**Subdivision - Lots 1 & 2 Baldivis Road,
Baldivis (1134)**

**Report and recommendations
of the Environmental Protection Authority**

**Environmental Protection Authority
Perth, Western Australia
Bulletin 939
June 1999**

Assessment No.1134

Figure 2. Plan of Subdivision (Source: Mitchell Goff & Assoc. 1998).

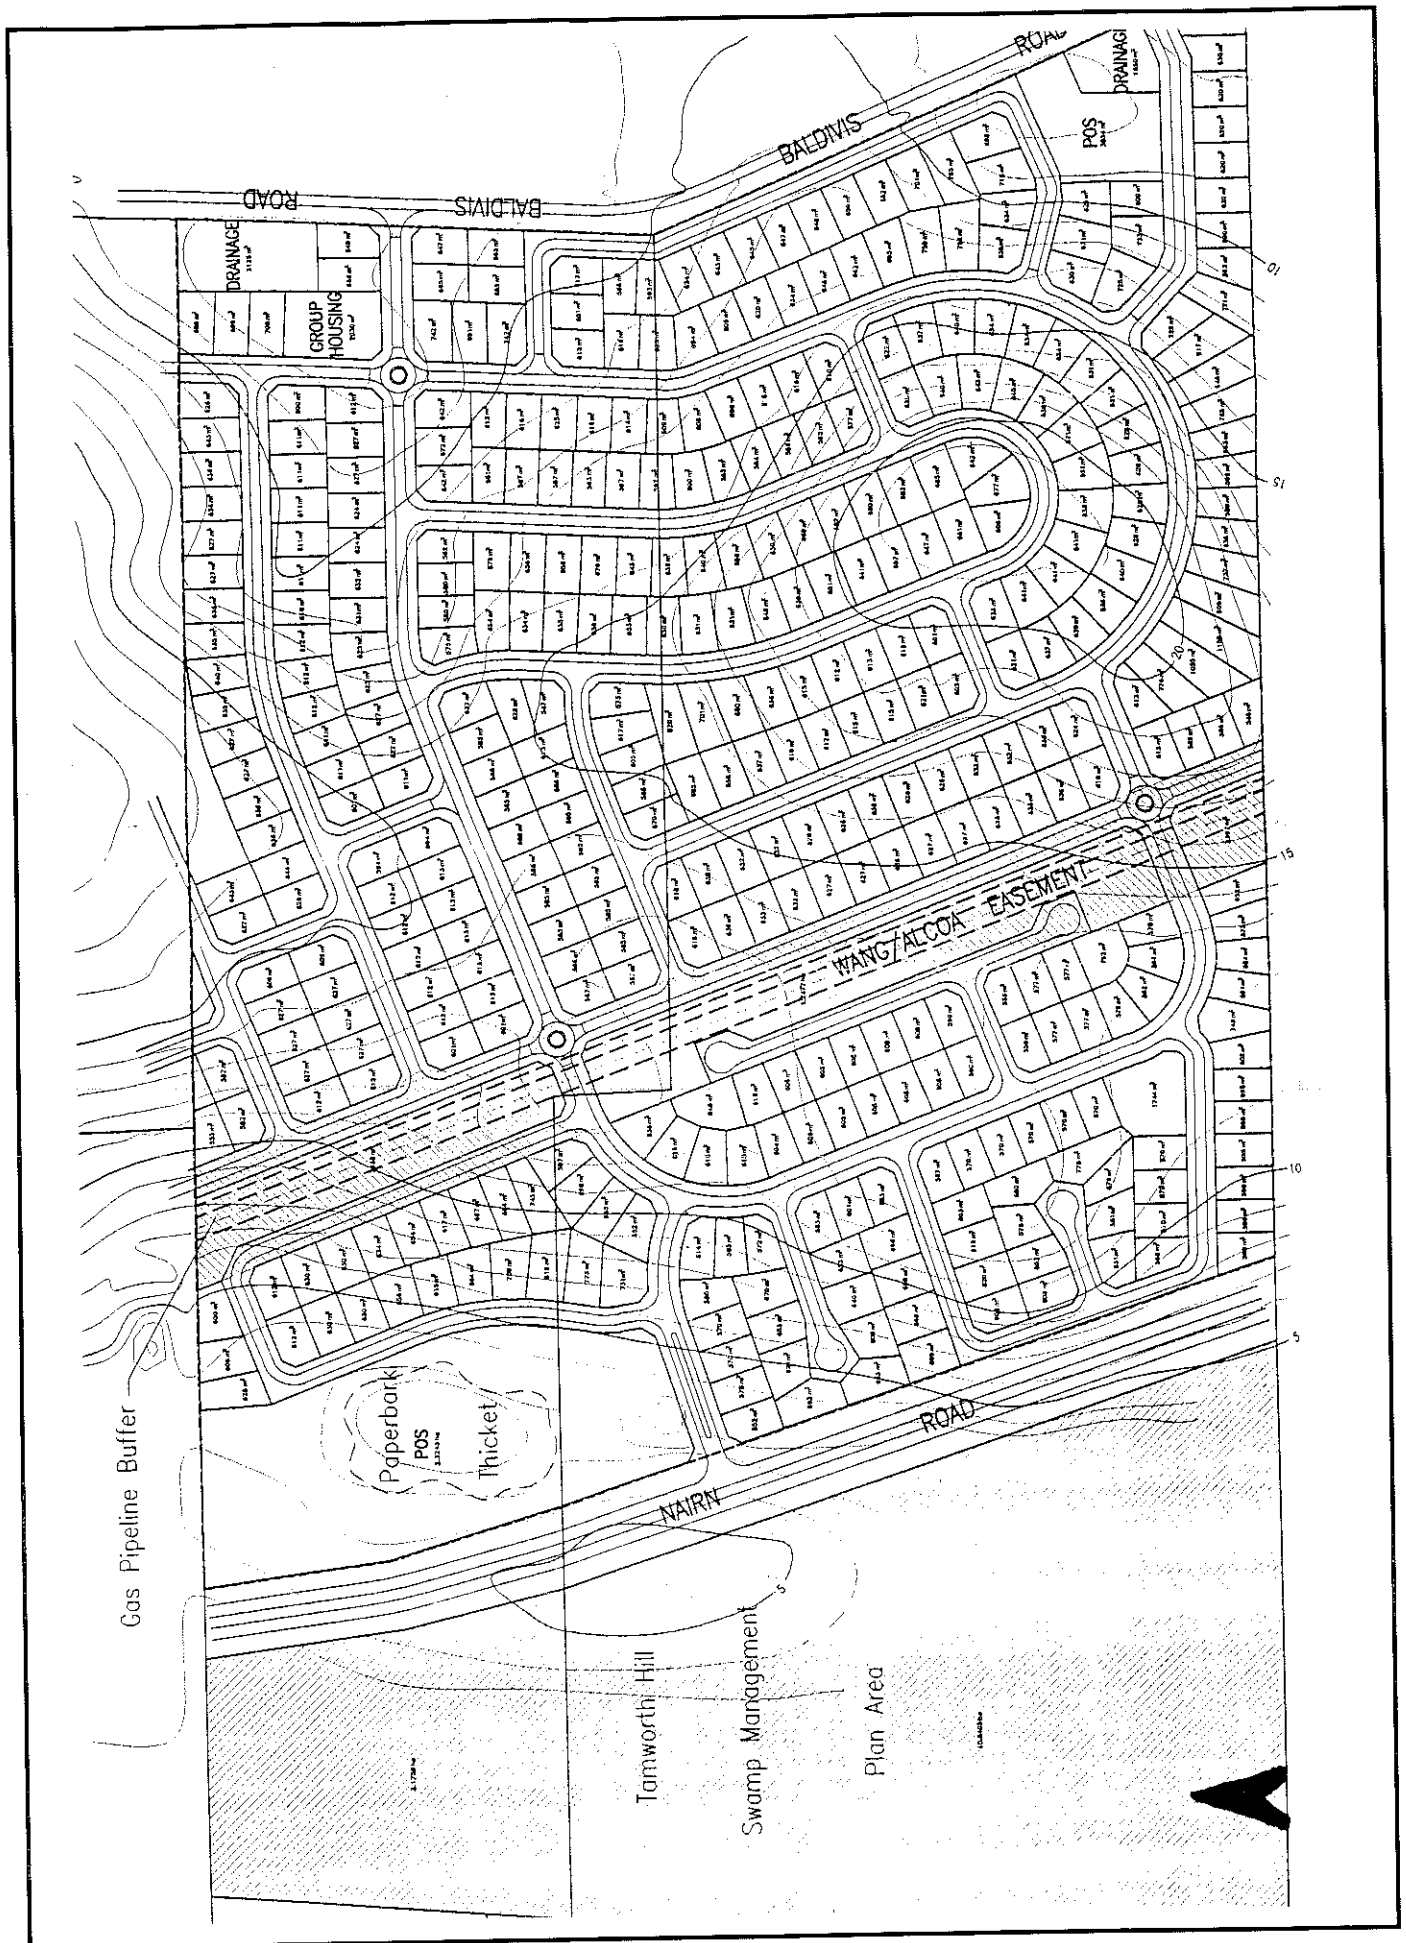
The CMS high pressure natural gas pipeline traverses the site in an approximately north-south alignment, within an existing 20 m wide easement. The route of the pipeline is clearly visible on the subdivision plan (Figure 2).

Submissions supported the 32 metre separation of residential lots to the gas pipeline, consistent with EPA requirements, as proposed in the revised subdivision plan submitted with the CER.

- 7.8 The subdivision plan (Figure 10) does not show the 32m separation between the easement and the residential boundaries. This buffer distance needs to be reflected. **(City of Rockingham)**

The 32 metre separation is between the centre of the pipeline and the boundaries of the residential lots and not between the edge of the easement and the boundary of the residential lots. Accordingly, the subdivision plan shows the correct buffer distance.
